Report to the Independent Planning Commission by Peter Dupen

Issues associated with Dendrobium Underground Mine Extension Project

Engaged by Environmental Defenders Office (EDO) on behalf of Protect Our
Water Alliance December 2020

Figure 1 – Reservoirs (blue), mining footprints (orange) in Metropolitan and Woronora Special Areas. Source – WaterNSW 1st submission to IEPMC (2018)

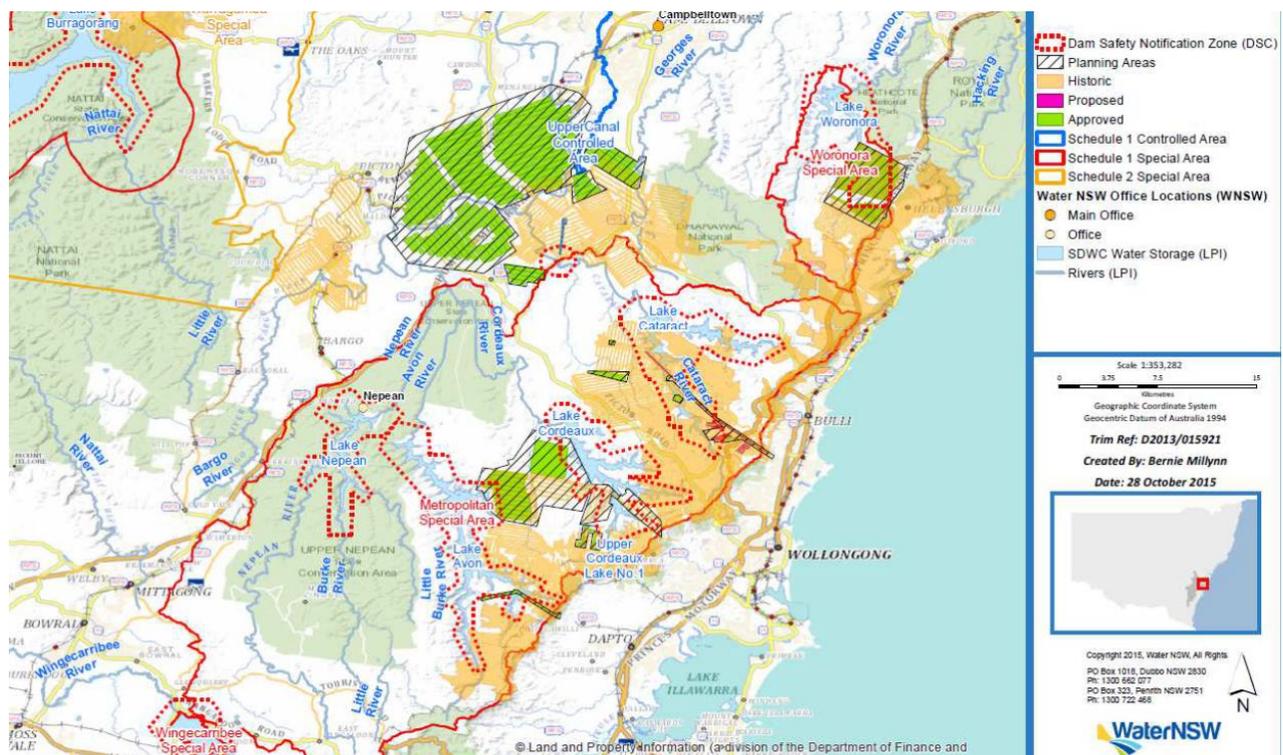
As highlighted by IEPMC and IAPUM, the most important understanding that has been confirmed in the past few years at Dendrobium Mine is that surface to seam cracking has been experienced over most of the existing mine's footprint (Figure 1). In other words, the unfractured or "constrained" zone which was hypothesised to provide ample protection to the overlying catchments (EcoEngineers, 2000) is not present over most of the existing Dendrobium Mine longwalls.

- The coal strata generally dip gently towards the west, away from the coast and consistent with the plateau topography (Figure 2). The coal seams are naturally more permeable than surrounding sandstones and siltstones, and may be viewed as a potential zone of increased drainage now connected to a myriad of underground workings (Figure 1) and goaves within the Illawarra Coal Measures
